<p align="center"><b>SUSPENSION MODIFICATION SERVICE BULLETIN</b></p>	UP 105 REV 1 2014-01-20
		Page 1 of 1

AMBULANCE TYPE: MX151D (63030 - 63079)

SUSPENSION MODIFICATION (BC)

# DRAWING : # 00904

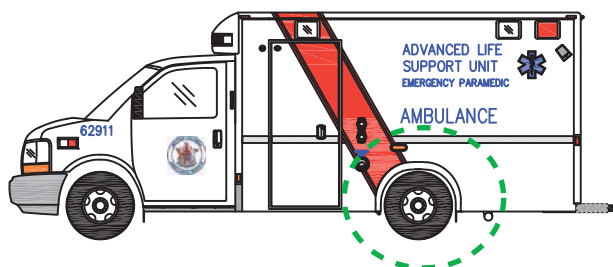
This bulletin is to inform owners of Demers Ambulances that a modification of the left (Driver side) suspension is required.

Modification of the driver side suspension is required during the next regular service scheduled. Please perform the modification as per the attach documentation.

DRIVER SIDE.

Remove left rear leaf spring as per workshop manual.

Lay springs on flat surface & install (2) C clamps.

Remove spring center bolt (through bolt) with clamps installed (note: may require vice grips on bottom to hold through bolt while removing upper 15mm nut on through bolt).

Install new center bolt into spring pack.  
Tighten nut properly and cut excess of bolt with die grinder.

Add new lower spring to leaf pack.

Reinstall spring pack in vehicle with new u-bolts, top plate and nuts as per workshop manual.
